**Addendum #1
April 10, 2019**

RFP 19-969

Fire & Security Alarm Monitoring & Testing

**Housing Authority of Kansas City
920 Main Street, Suite 701
Kansas City, MO 64105**

TB Watkins - Sprinkler Controller

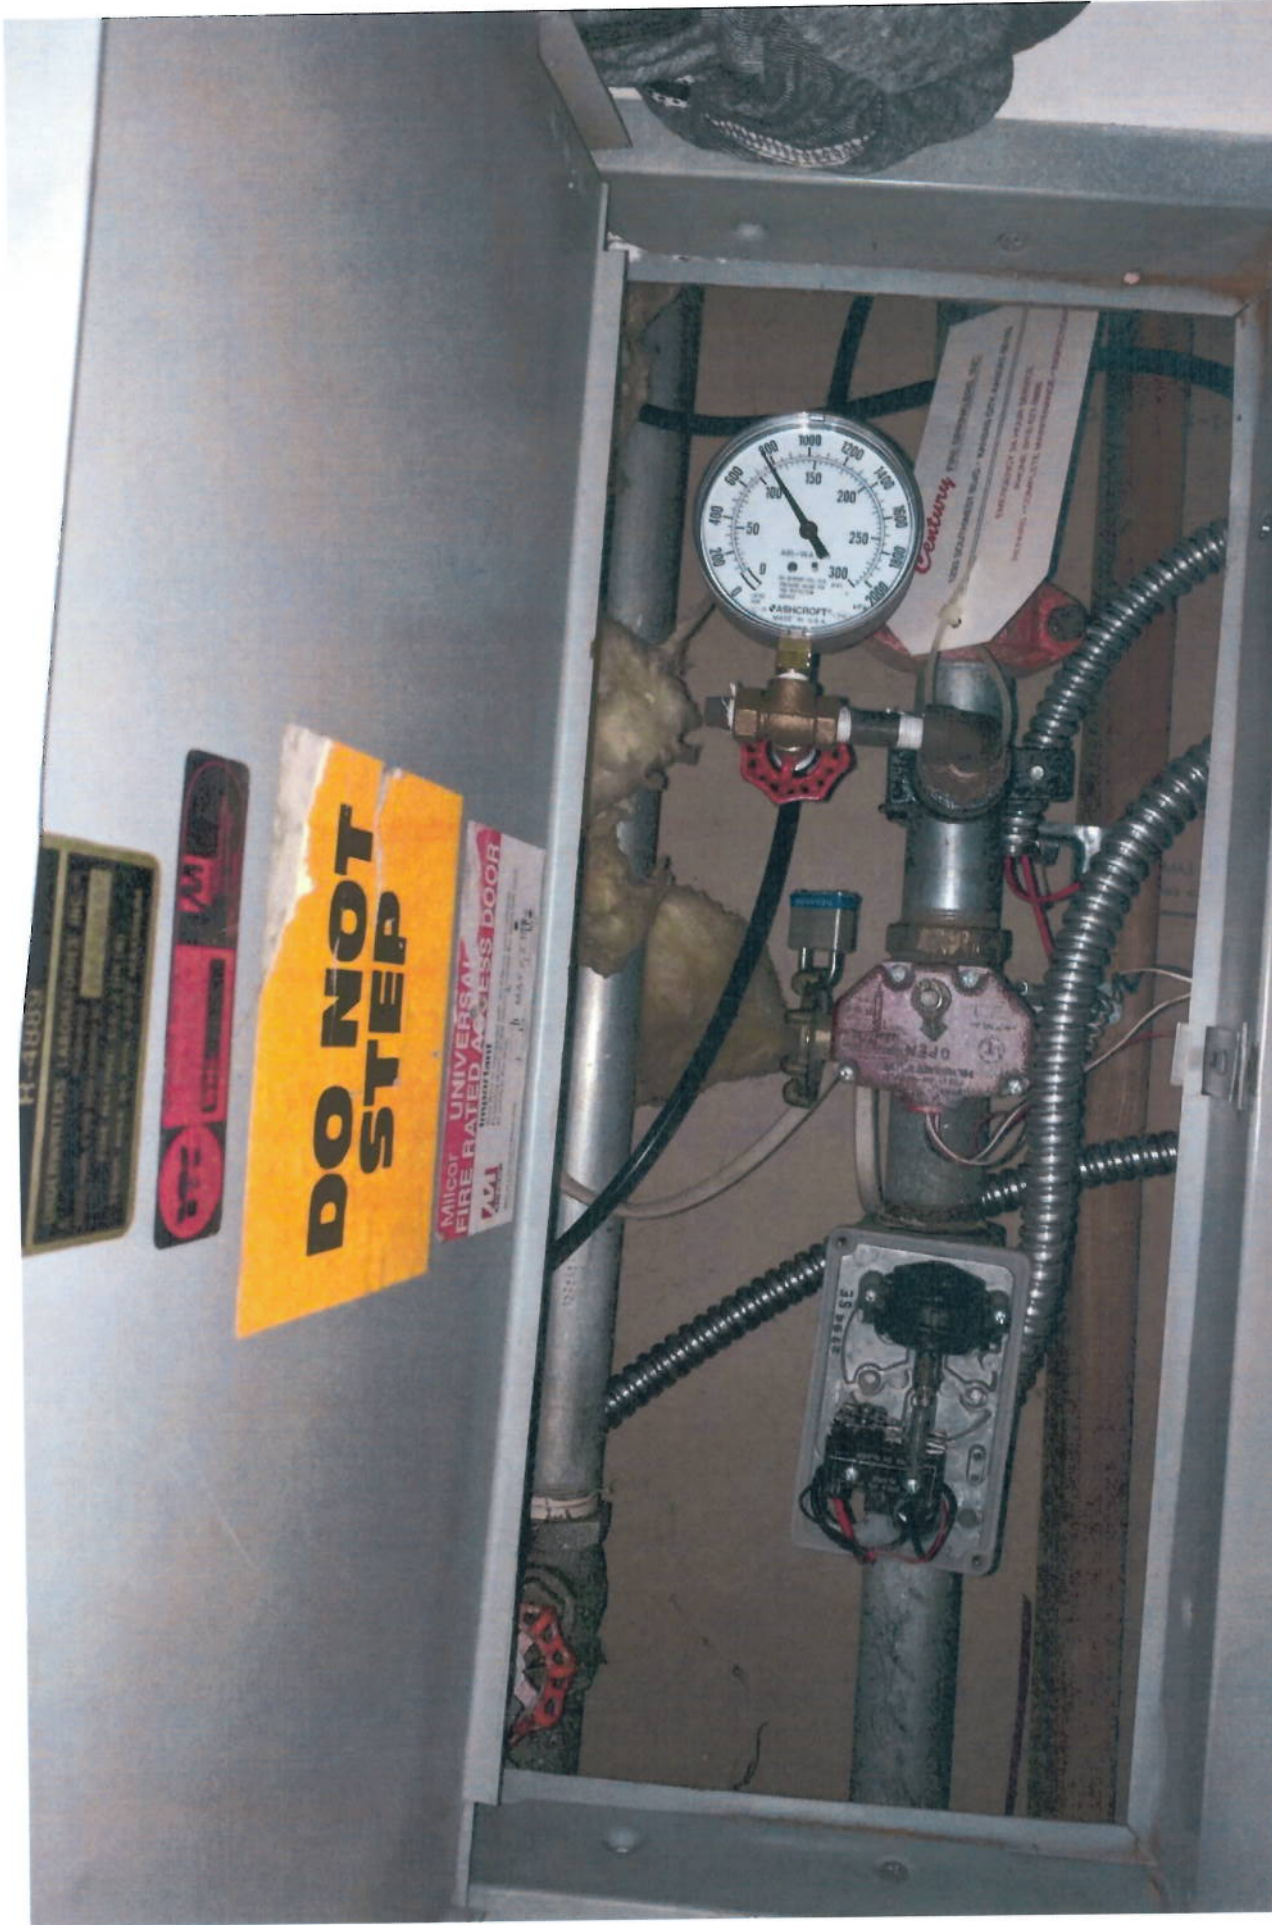
3. At TBW pre-bid meeting we could not get into an apartment to check the sprinkler controllers that are installed in one apartment in each of the 20 buildings. We checked 1607 E. 12th Terr #3 and found the exterior fire alarm and connections. A picture within the apartment has been provided (attached) of the **installed electronic alarm equipment** located in the in the closet.
 - The sprinkler controllers that are installed in one apartment in each of the 20 buildings is right.
4. The pre-bid meeting attendees asked if they could get a copy of the most recent alarm inspection for each of the developments in the RFP so that they can know exactly how many pull stations and other equipment is in each of the developments.
 - A sample copy of most recent alarm inspection reports is attached.
